SUNDRY NOTICES AND REPORTS ON WELLS

1. Type of Well: Gas	8. Well Number 118M
2. Name of Operator HILCORP ENERGY COMPANY	9. OGRID Number 372171
3. Address of Operator 1111 Travis Street, Houston, TX 77002	10. Pool name or Wildcat

WELL API NO.
30-039-31483
5. Indicate Type of Lease
STATE [X] FEE []
6. State Oil & Gas Lease No.
EO-289-56
7. Lease Name or Unit Agreement Name
SAN JUAN 29-6 UNIT
8. Well Number 118M
9. OGRID Number
372171
10. Pool name or Wildcat
DK - BASIN:: DAKOTA
MC - BASIN:: MANCOS
MV - BLANCO:: MESAVERDE

Subject: Fw: [EXTERNAL] FW: Hilcorp - San Juan 29-6 Unit #118M - 7" Intermediate Casing CBL
Sent: 8/26/2025, 7:31:15 AM
From: Rikala, Ward, EMNRD <Ward.Rikala@emnrd.nm.gov>
To: Richy Winningham
Attachments: [Hilcorp San Juan 29-6 Unit 118M Sector Bond Log 3.pdf](#)

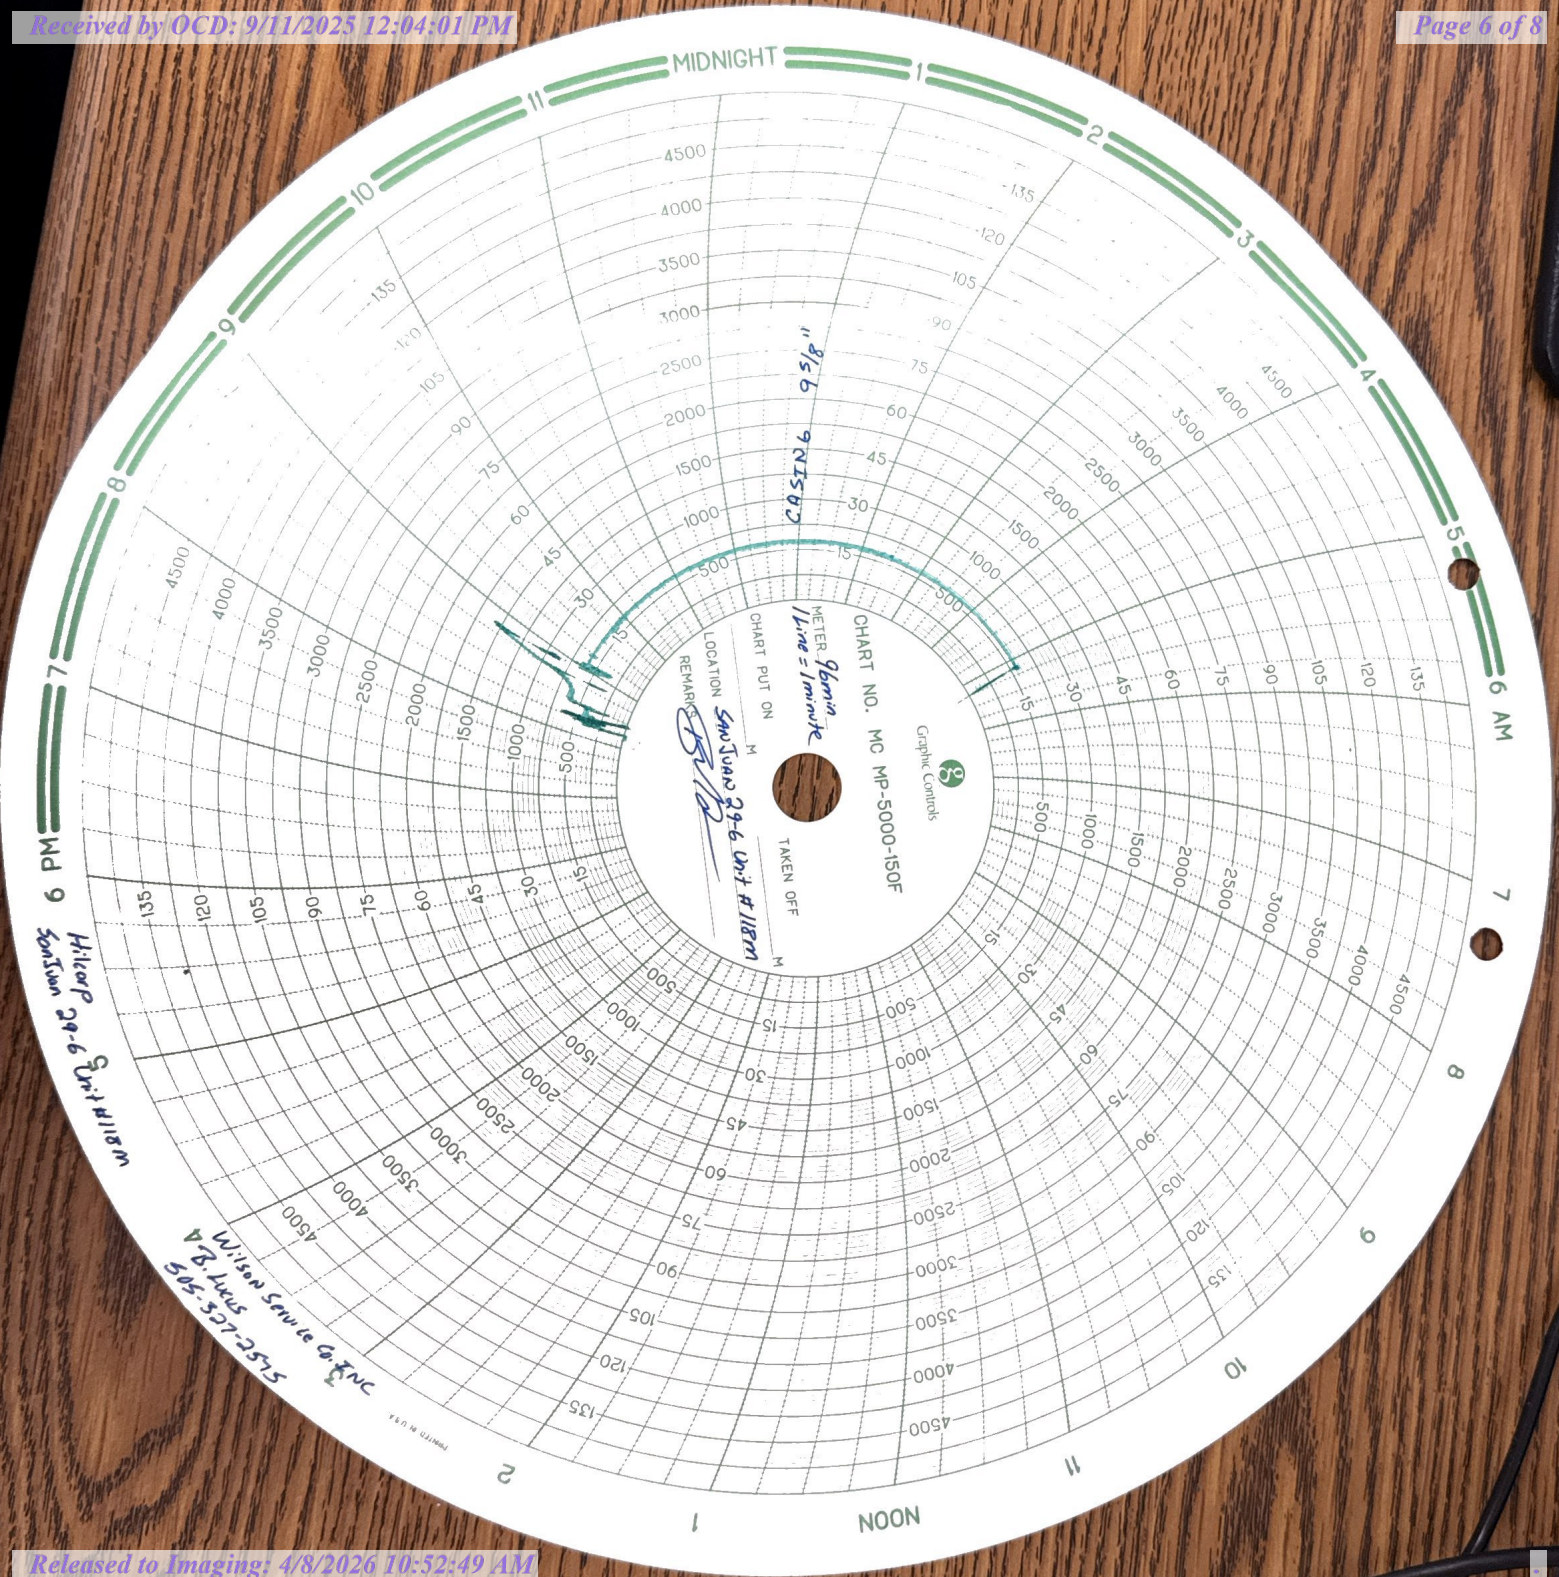
I have attached the CBL that was run on the San Juan 29-6 Unit #118M well. We had previously discussed the intermediate cement job on this well due to the fact that cement returns were not seen at surface during the cement job, although the volume numbers calculated indicated that cement returns should be very near surface.

The CBL shows there is good cement bond from surface to ~800' and from 2,500' to the 7" casing shoe, with reasonable cement bond from 800' to 2,500'. Please note that the top of the Fruitland coal was picked by the mud logging company (Soft Rock) at 3,356' MD on this well via cuttings sampling.

Please review the attached CBL and let me know if we have approval to move forward with drilling the 6-1/4" production hole section to ~8,100' and then casing it with 4-1/2" casing.

Approved to go ahead.
